# STS-109 FLIGHT READINESS REVIEW

February 14, 2002

**Ground Operations**

### ENGINEERING TOPIC ET HYDROGEN UMBILICAL RETRACT ANOMALY (STS-108)

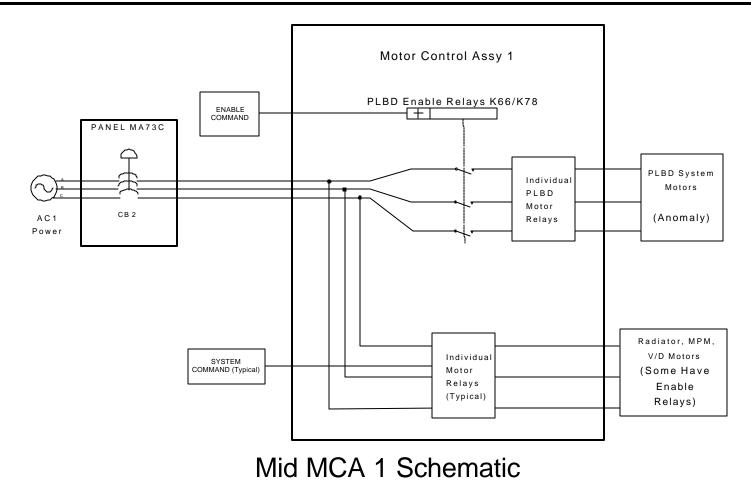
- Observation
  - While closing Payload Bay Doors (PLBD's) at the Pad, Midbody AC1 Phase-A was not received at several latch/door drive motors (Phases B & C were nominal)
    - The anomaly was present on motors common to Mid Motor Control Assembly 1 (MCA 1)
- Concerns
  - A repeat of the anomaly during the mission
    - Affected motor-set (MCA-1) operation would still occur on 2 of 3 AC phases
    - Redundant motor-set is unaffected

- Discussion
  - There have been prior occurrences of this nature
    - Caused by dirty circuit breaker contact, subsequently cleared
  - Mid MCA 1 receives AC 1 power from Panel MA73C, Circuit Breaker 2 (CB 2)
    - This isolates the anomaly to MCA 1, Panel MA73C, or the path between components
  - A repeat of this anomaly during the mission would only be visible on the ground through motor current draw data
    - Motors would operate on 2 phases

- Possible Causes
  - Intermittent failure of copper path between Panel MA73C and Mid MCA 1
    - Highly unlikely no activity outside of breaker switch operation
    - No current draw signature indicating intermittent open/short
  - Dirty Phase A contact on one of the Mid MCA 1 Enable Relays (K-66/78), subsequently cleared with relay cycle
    - Unlikely not a common failure
  - Dirty contact on Phase A of CB2 on Panel MA73C
- Most Probable Cause
  - Dirty contact on Phase A of CB2 on Panel MA73C
    - This condition has been seen multiple times on same configuration breakers

- Flight Rationale
  - The loss of Phase A (2 of 3 good phases) will not prevent the operation of the PLBD motors
    - Three phase AC motors have a sub-level of redundancy by design
  - A redundant set of motors for all PLBD operations are unaffected by this anomaly
    - Different circuit breakers, MCA and copper path
  - PLBD latches will be cycled 10 times to exercise enable relays
  - PLBD and V/D motor current draw will be monitored through remainder of door operations at the Pad
    - All MCA AC circuit breakers paths will be verified after final launch count positioning with V/D operations
  - CB 2 will be left closed for remainder of ground processing, and is only opened during the mission for contingency starboard radiator deploy ops

- Risk Assessment
  - No risk to Flight and Crew's safety or Mission success

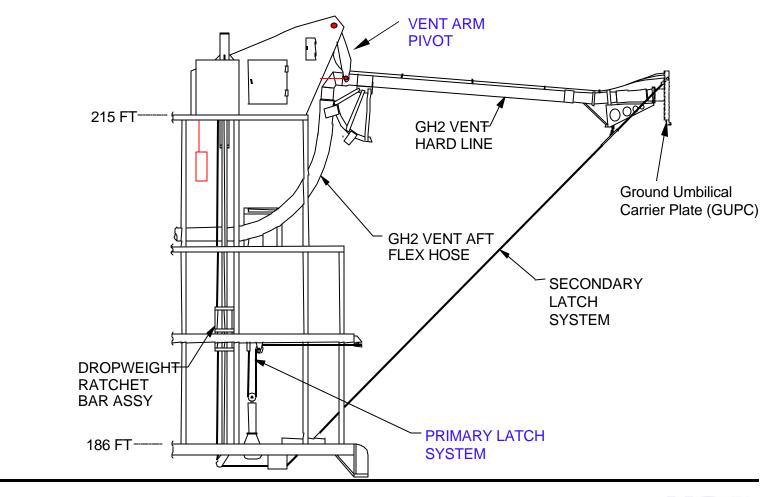
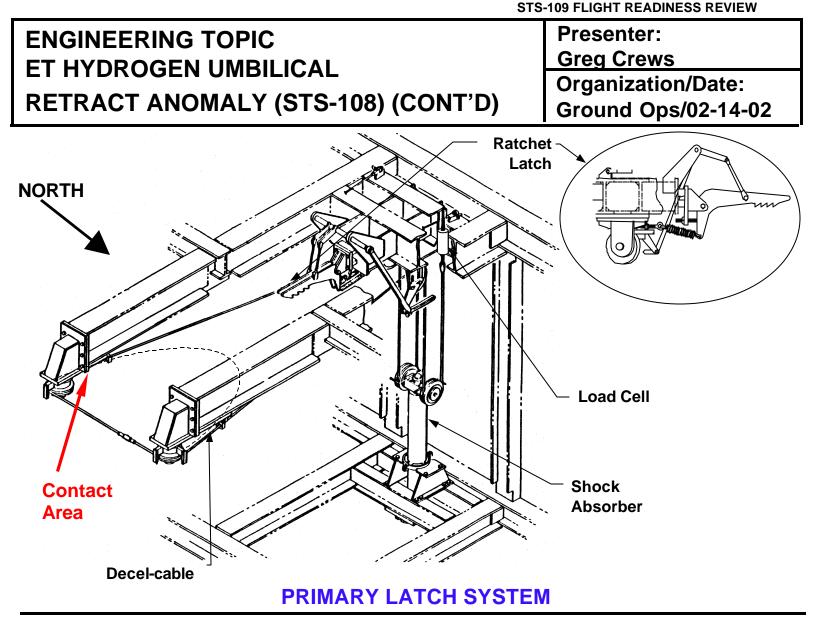
- Observation
  - During STS-108 (Pad B), the Hydrogen Vent Arm contacted the Fixed Support Service Structure (FSS) just prior to engaging the primary latching system, causing hardware damage to the vent arm and FSS
    - The vent arm was captured by the secondary capture feature as designed
- Concern
  - Potential debris impact with vehicle
  - Damage to Ground Support Equipment

**Pivot Arm Shocks**

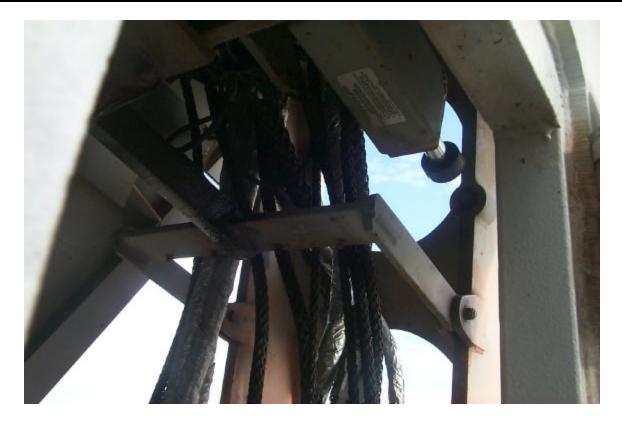
- RETRACT ANOMALY (STS-108) (CONT'D)
  - Discussion
    - No prior occurrences of Vent Arm contact with structure
    - Pivot Arm Withdrawal Weight reduced from 2000 to 1500 lbs prior to 'Return-to-Flight' (STS-26R)
      - To increase GUCP Pyro bolt margin
    - Vent arm has been contacting the deceleration cable south of center since withdrawal weight change
    - A USA/NASA team composed of Operations, SR &QA and Engineering was formed to perform investigation
      - Fault Tree generated and addressed
        - 86 items addressed
        - 2 open items remaining

- Actions Taken / Fault Tree Analysis (Cont'd)
  - Fault Tree open items
    - Pivot Arm Shocks (1.11.1)
      - Pad B pivot arm shocks sent to lab for testing
        - High load required to compress north shock
        - Could decrease centering capability and cause arm to drop south
      - Pad A shocks to be removed/tested ECD 2/22
    - No constraint to Pad A pending nominal shock installation

RETRACT ANOMALY (STS-108) (CONT'D)

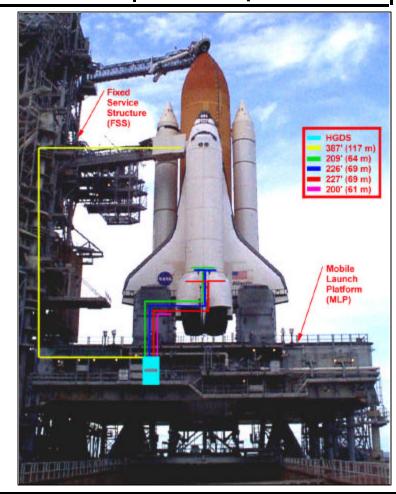
- Actions Taken For STS-109 (Pad A)
  - Gained additional clearance on south side of deceleration cable structure (STS-108 contact area)
    - Removed 1  $\frac{1}{4}$  inch from bracket on structure
      - Pad A south deceleration structure is <sup>3</sup>/<sub>8</sub> inch further south than Pad B
  - Removed vent line lifting bracket debris source during STS-108
  - Pivot arm shocks to be tested for nominal operation
  - Deceleration cable painted to help determine contact point
  - Additional cameras (4) installed to better evaluate system dynamics
  - Bright tape added to structure and vent line in previous contact area to aid in film analysis

- Flight Rationale
  - Fault Tree analysis is complete no constraint for Pad A
  - Due to Pad A vent arm north off-set, Pad A vent arm has more clearance to the deceleration structure
  - Additional clearance obtained at previous contact area
    - Material removed from south side structure bracket
  - Lifting bracket (sheared off during STS-108) removed to mitigate debris risk
  - Pivot arm shocks will be tested (open work brief at L-2)
- Risk Assessment
  - No risk to Flight and Crew's safety or Mission success
